Big Ticket Consensus Discussion Slides

Beth Kochuparambil

October 13 & 14

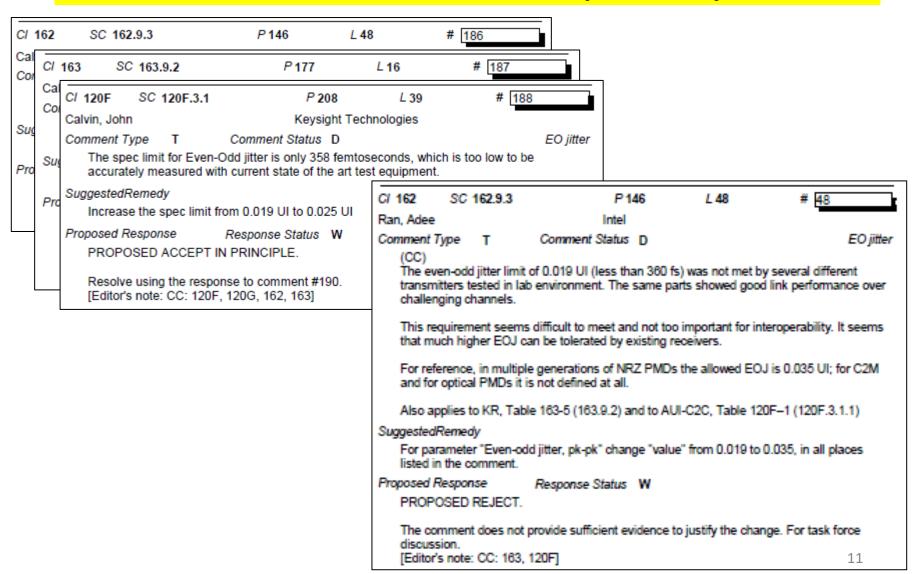
Based on Sleigh/Calvin/LeCheminant presentation

https://grouper.ieee.org/groups/802/3/ck/public/adhoc/sept16_20/calvin_3ck_adhoc_01_091 620.pdf it has been shown that the EOJ measurement is susceptible to a systematic error based on the test pattern length and baud rate. This is easily resolved by allowing the CDR loop BW to be reduced below 4 MHz

Update the text of page 210 line 43 to read Even-odd jitter is calculated using the measurement method specified in 120D.3.1.8.2. with the exception that EOJ may be measured with a clock recovery unit (CRU) with a corner frequency of <= 4 MHz and a slope of 20 dB/decade

PROPOSED ACCEPT IN PRINCIPLE.

Comment #127 proposes using PRBS9Q rather than PRBS13Q.

Comment #190 proposes reducing the scope CRU bandwidth.

Comment #188 proposes to increase the value from 0.019 UI to 0.025 UI.

Discussion is required to determine and appropriate solution.
